# EASTERN CORRIDOR SEGMENTS II AND III (PID 86462) US 50 CORRIDOR FOCUS AREA ADVISORY COMMITTEE MEETING NOTES

## Meeting Dates

**Figure 50-5**  
**RESTRIPE PAVEMENT TO MAINTAIN TWO LANES**  
**IN EACH DIRECTION ON WOOSTER PIKE**

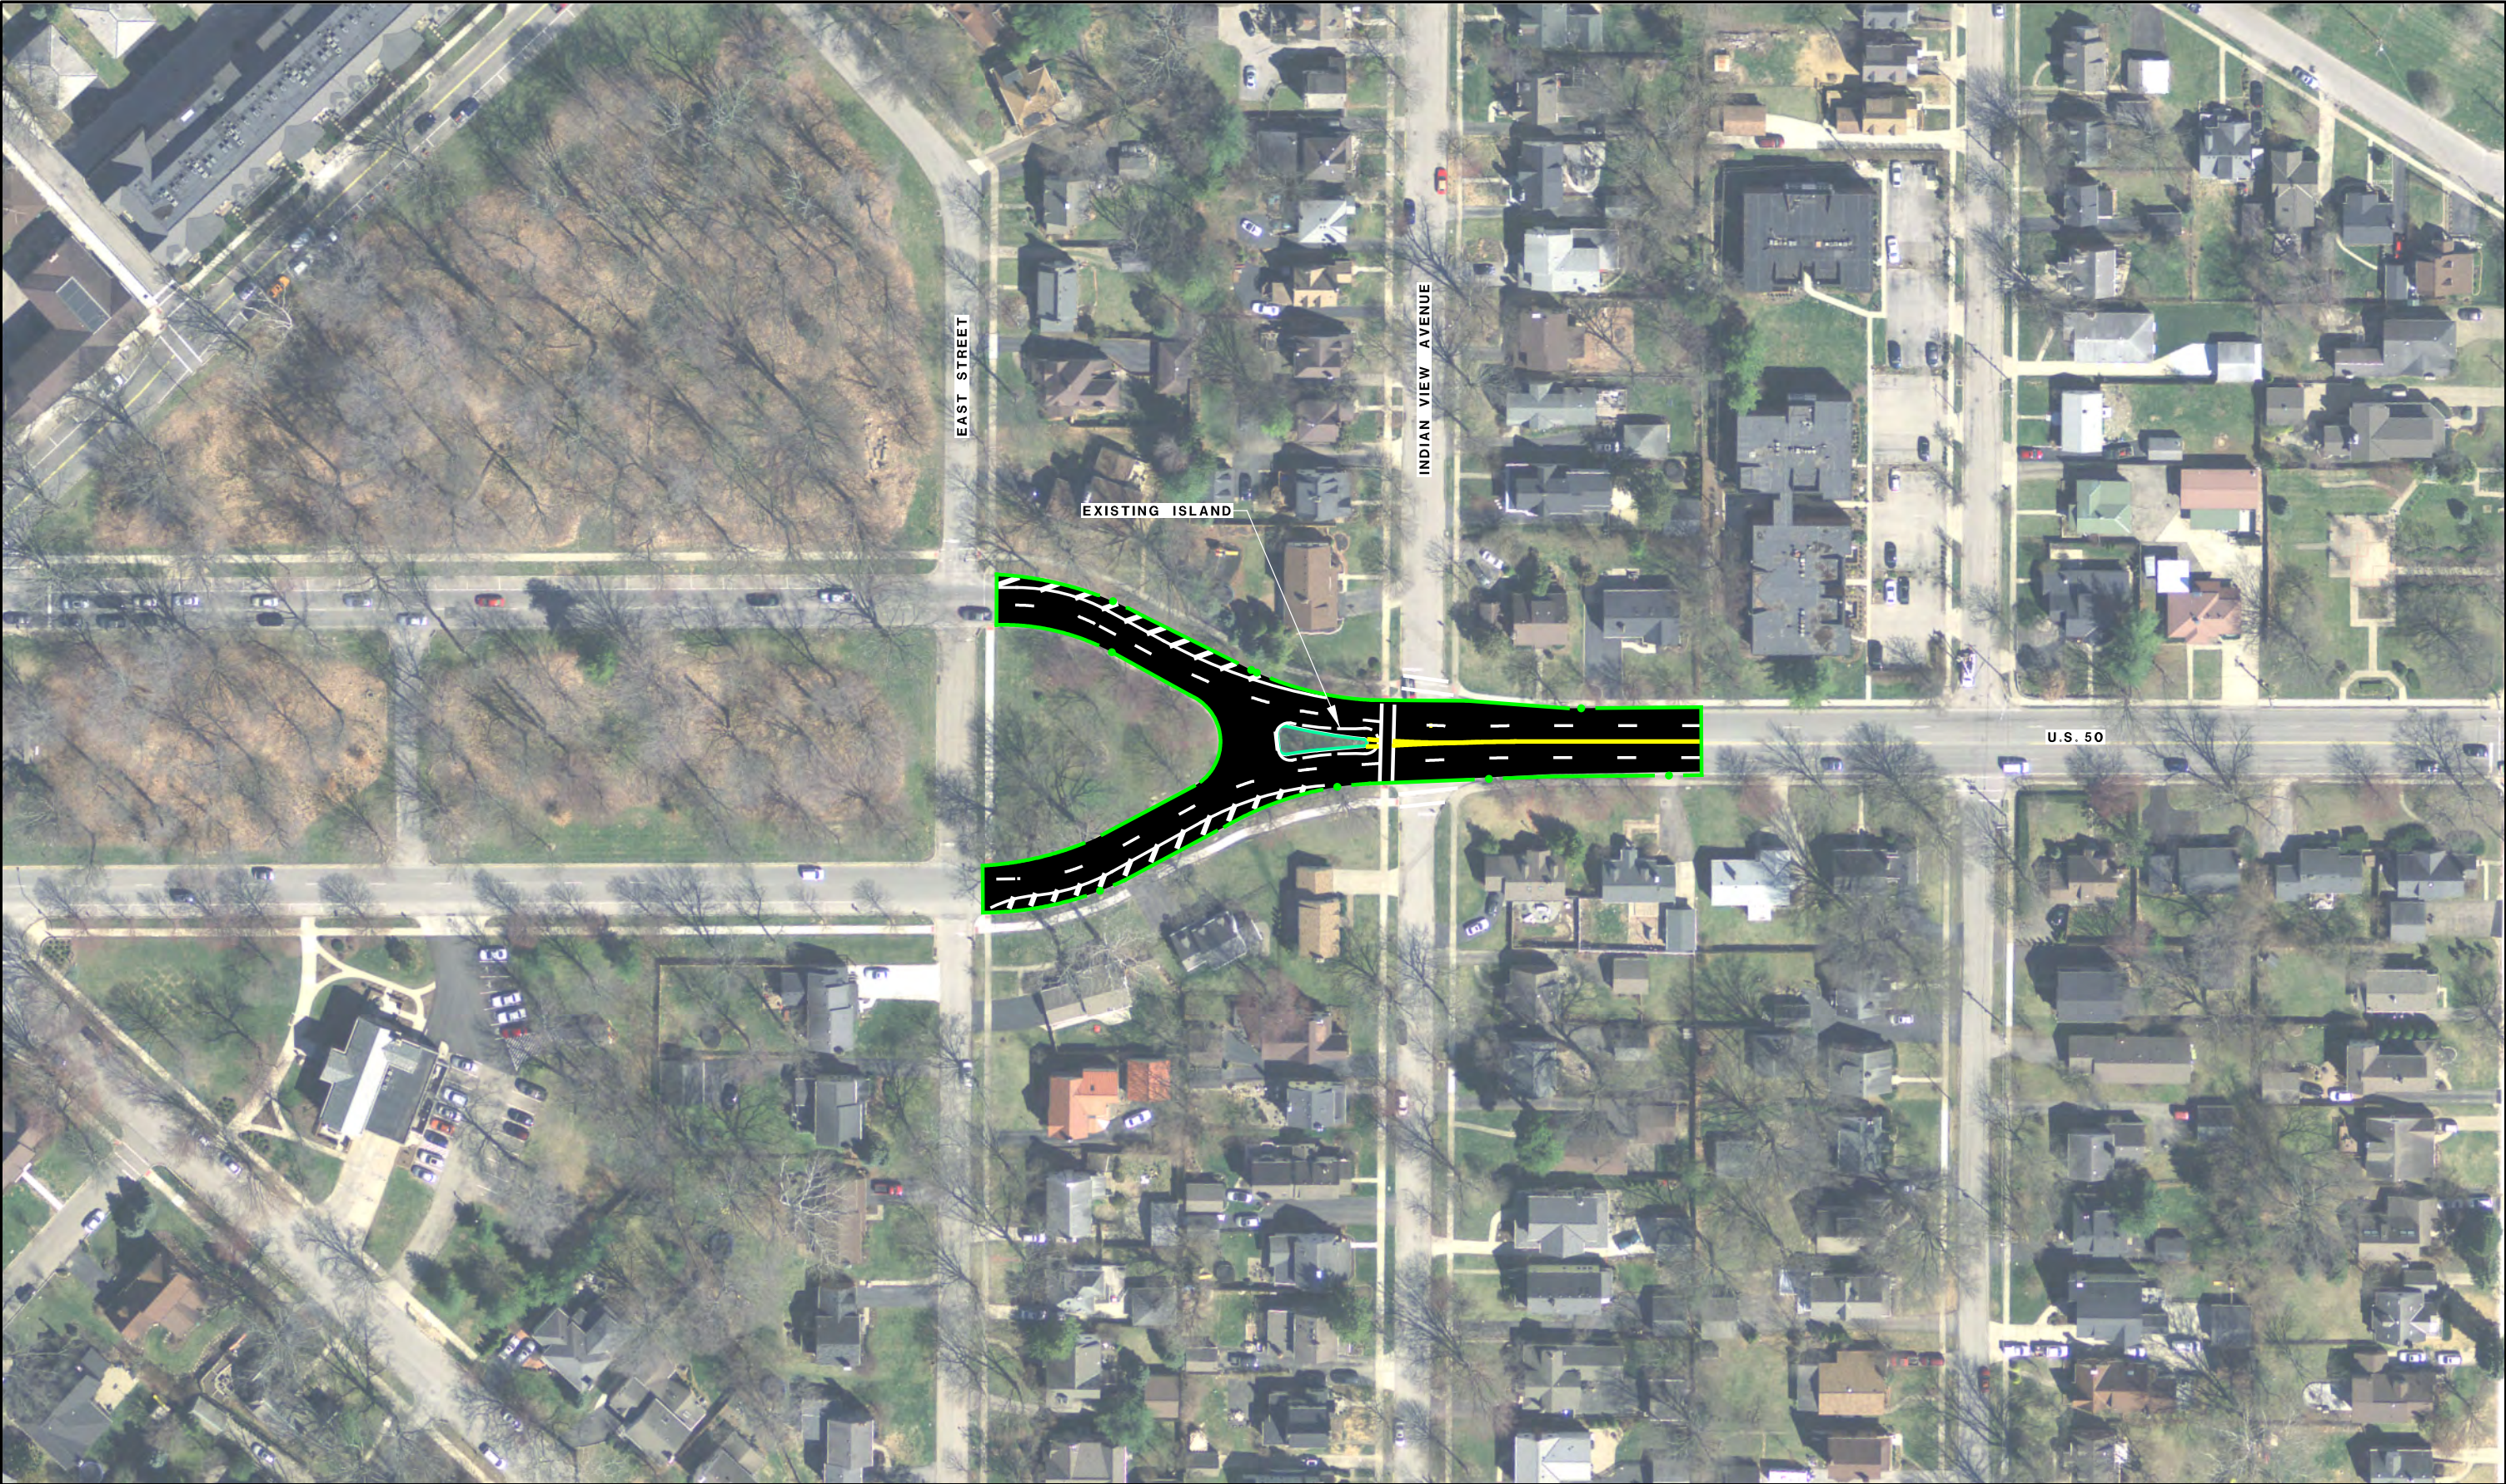
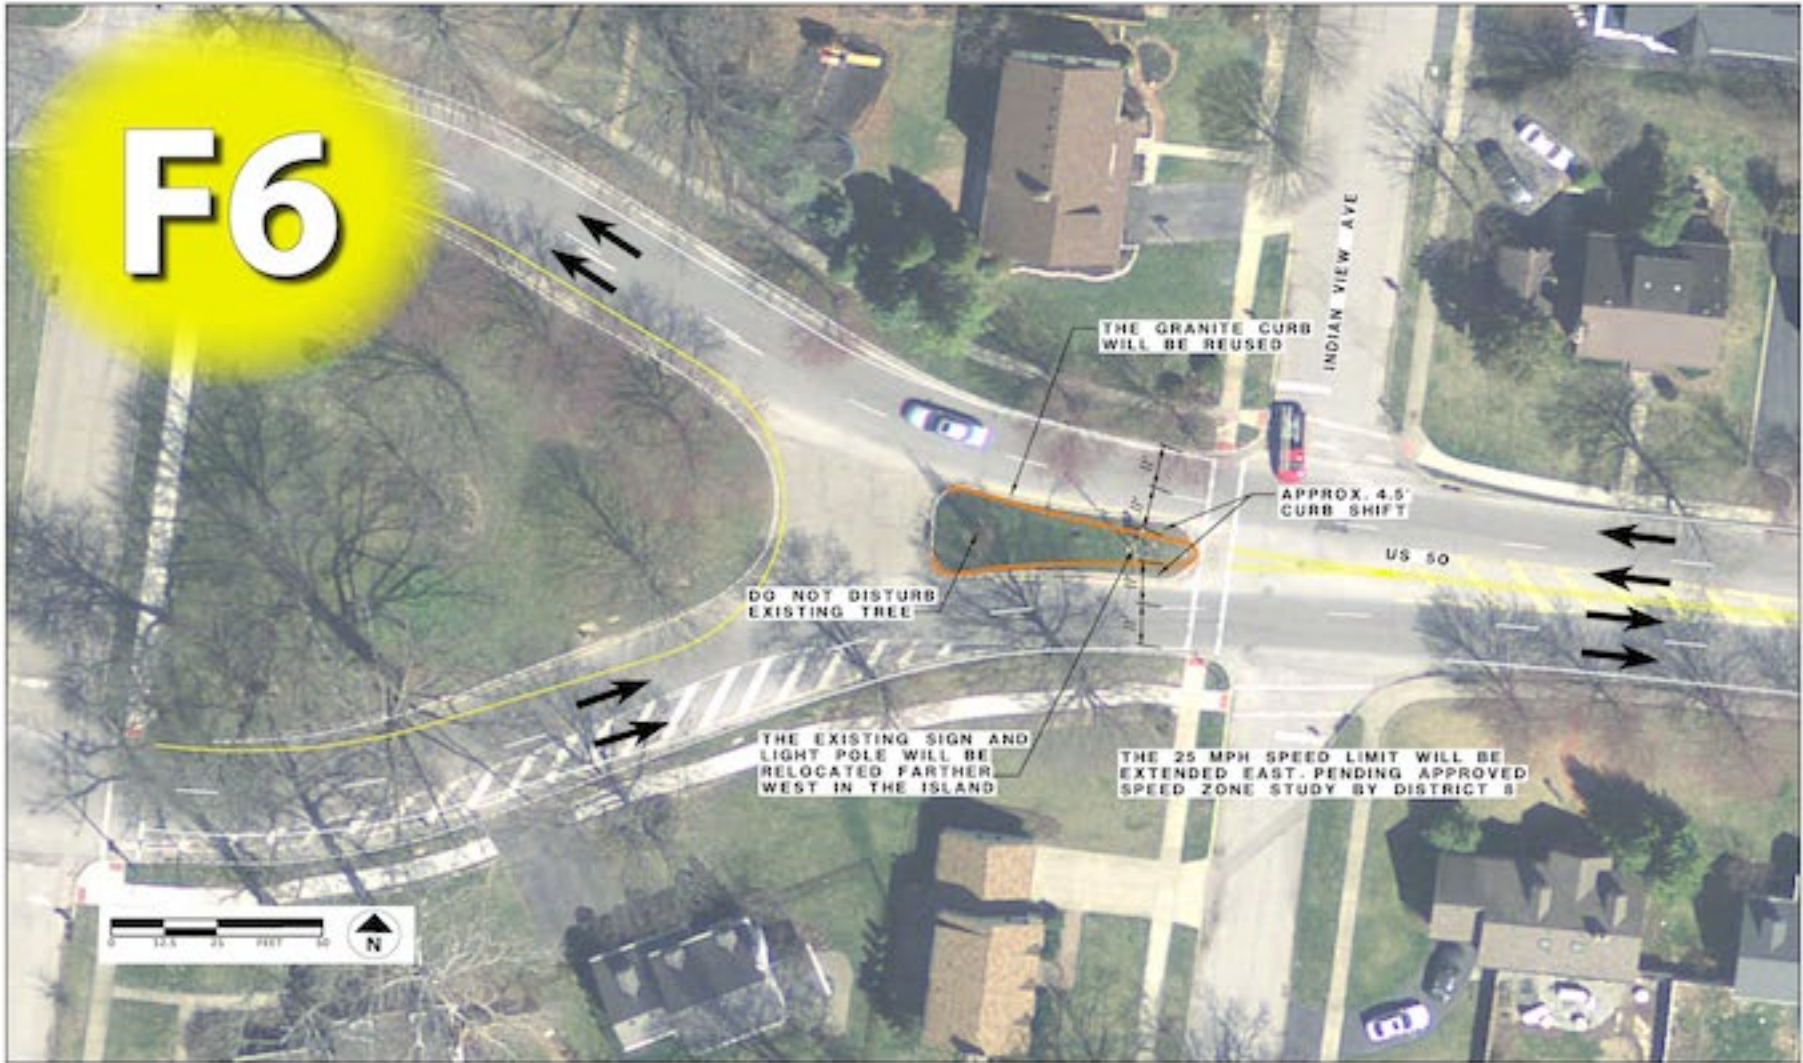
- The Advisory Committee discussed reducing the travel speed within the area from 35 mph to 25 mph. As part of its evaluation of this concept, ODOT completed a speed study for this area; results indicate that it makes sense to consider reducing the travel speed to 25 mph. This change would especially be beneficial if the travel lanes between East Street and Petosky Avenue are increased from one to two (the curves in this area would be designed for a travel speed of 30 mph).

- Reasons respondents gave for disliking or opposing this concept included concerns that vehicles would travel faster through the area if an additional travel lane is added, and, the change would impact John Nolen’s original design for the community at this location.

- ODOT’s Office of Environmental Services (OES) would like to review this project with the Village of Mariemont in more detail; the State Historic Preservation Office did not express any specific concerns.

- This project is on hold because the Mariemont Planning Commission voted to not approve the proposed change in January 2019.

POST MEETING NOTE: The Mariemont Planning Commission voted in January 2019 to not approve the proposed change. Therefore, the lane modification will not be taking place in conjunction with the proposed resurfacing work (PID 101309) in 2019.
